Release Note

Date:	1/4/02	Model(s)	DigiLink 2701 (DL2701)
--------------	--------	-----------------	------------------------

Corrections to Product Manual

The following information is listed incorrectly in the *DigiLink 2701 Installation and Operation Guide* (P/N 200-000691-00 rev: A). This information will be corrected in the next release of the manual.

Temp High LED information incorrect in product manual

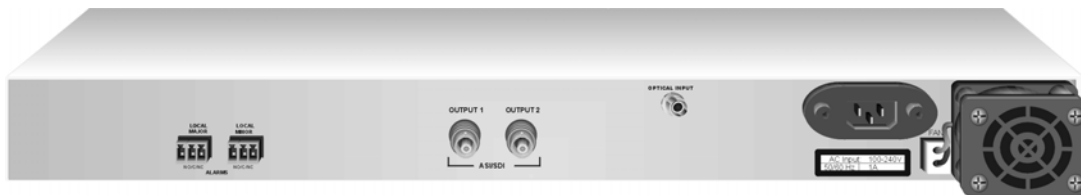
The color of the TEMP HIGH LED—located on the front panel of both the DL2701 encoder and DL2701 decoder—is yellow, not red as stated in manual. This LED is used to indicate that the internal system temperature limit has been exceeded, which is a minor alarm condition.

The following tables in the manual contain information related to this LED and will be updated with the correct information on the next release:

- Table 3-3, page 3-10
- Table 4-3, page 4-9

DL2701 Decoder has two, not one, ASI/SDI output ports

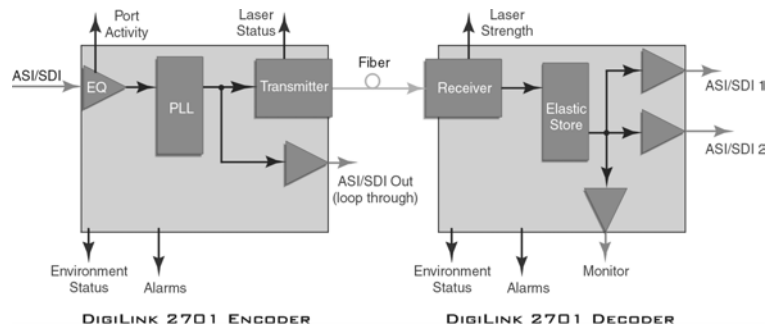
The manual currently describes the DL2701 decoder as having only one ASI/SDI output port located on the rear panel. This product has two such ports with identical specifications as shown in the following corrected illustrations:

- Rear panel view (Figure 4-2, page 4-3)

- Block diagram (Figure 1-1, page 1-7)
